**13/02860/MPLAN: THE INVERARAY PROJECT: MAST 1/5 - MASTERPLAN REPORT**

**1. SUMMARY**

**USING KEY PRINCIPLES TO GENERATE A FRAMEWORK PLAN**  
(NB : The detailed layout of development is subject to detailed master plans for each phase of development)

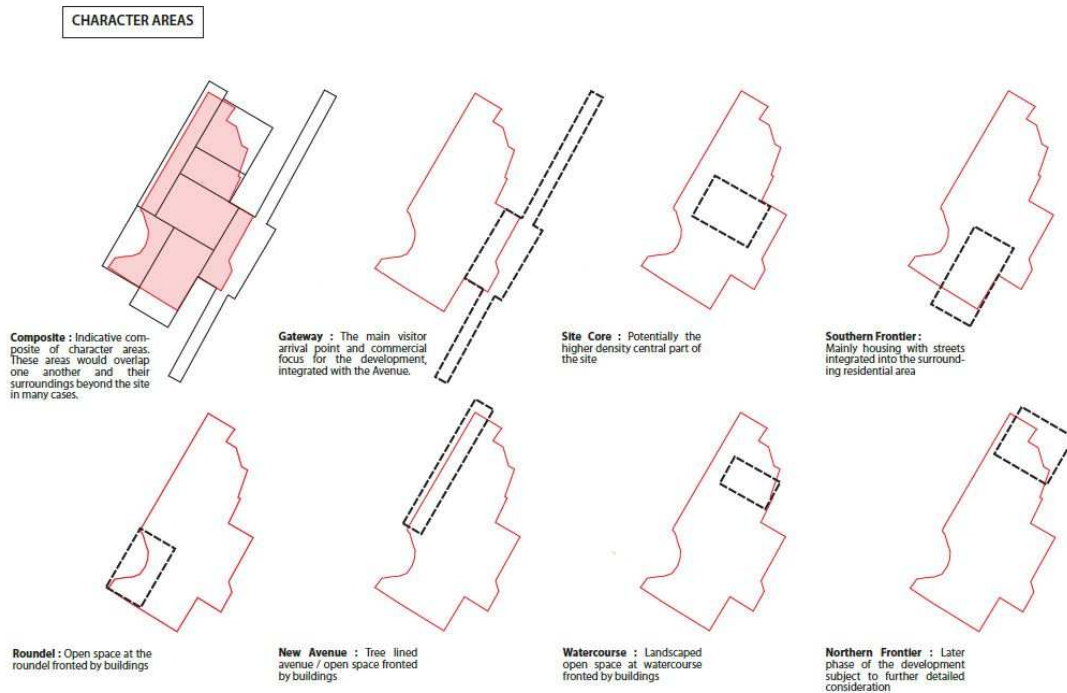
Whilst the masterplan does not include a detailed layout for development within the site area it does include a Framework Plan which has been built up taking into account the existing site constraints and opportunities, the practicalities of achieving access and aspirations for connectivity, intended land uses and an urban built form to provide an indicative framework plan/layout for the development.

It is, however, considered that the present framework document, along with the specific Development Brief provided for the development of Phase 1, between them provide sufficient reassurance that it is compatible with the vision for the overall site and that it will not prejudice the delivery of the remainder of the development within the masterplan area. Phase 1 is capable of proceeding without the requirement for any major infrastructure upgrades (other than off-site footpath works to make safe the highway route from Barn Brae), whilst it will not
